2. NPE-86/02 and OLCR-NLS-86/01

SUBJECT: Technical Specification 4.7.1.1.a.2, page 3/4 7-2  
Facility Operating License No. NPF-29, pages 7 & 8

3. PS-86/04

**SUBJECT:** Technical Specification 4.3.4.2.3, page 3/4 3-42; Bases For Specification 3/4.3.4, page B 3/4 3-3; and Definition 1.13, page 1-3.

(20) Standby Service Water System (Section 9.2.1 SER, SSER #2)

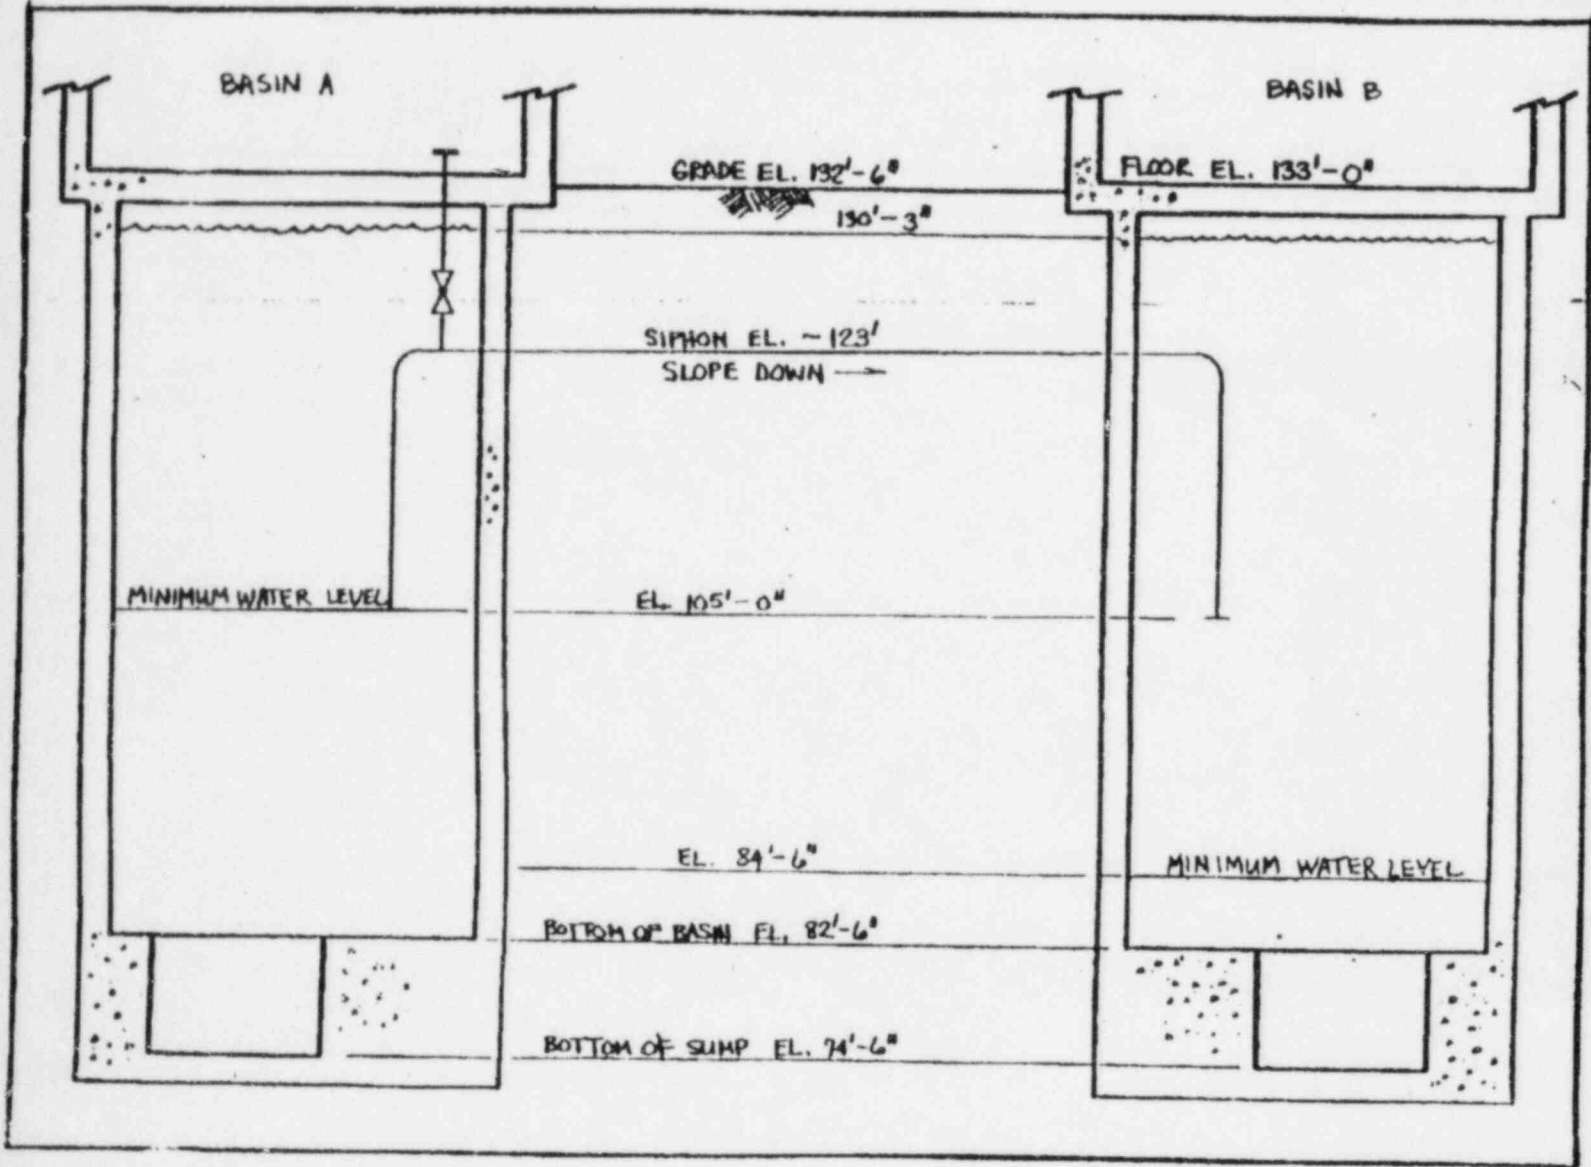
~~No irradiated fuel may be stored in the Unit 1 spent fuel pool prior to completion of modifications to the standby service water~~

~~(SSW) system and verification that the design flow can be achieved to all SSW system components. However, should a core offloading be necessary prior to completion of these modifications (scheduled for the first scheduled refueling outage), irradiated fuel may be placed in the spent fuel pool when the RHR system operating in the spent fuel pool cooling mode is available. Until the SSW system is modified, the spent fuel pool cooler shall be isolated from the SSW system by locked closed valves or the associated SSW subsystem shall be declared inoperable. The position of these valves shall be verified every 31 days until the design flowrate for SSW system is demonstrated. The surveillance to be performed is to verify that any SSW loop with valves which are not locked closed is declared inoperable.~~

INSERT TO LICENSE CONDITION 2.C.(20).

(20) Standby Service Water System (Section 9.2.1 SER, SSER #2)

No irradiated fuel may be stored in the Unit 1 spent fuel storage pool prior to completion of modifications to either loop A or loop B of the standby service water (SSW) system and verification that the design flow can be achieved to all essential SSW system components in the modified loop. However, should a core offloading be necessary prior to completion of these modifications (scheduled for the first refueling outage), irradiated fuel may be placed in the spent fuel pool when the RHR system operating in the spent fuel pool cooling mode is available. Until the SSW loops are modified, the spent fuel pool cooler in an unmodified loop shall be isolated from the loop by locked closed valves or the loop shall be declared inoperable. The position of these valves shall be verified every 31 days until the design flowrate for the SSW loop is demonstrated. The surveillance to be performed is to verify that any unmodified SSW loop with valves which are not locked closed is declared inoperable.
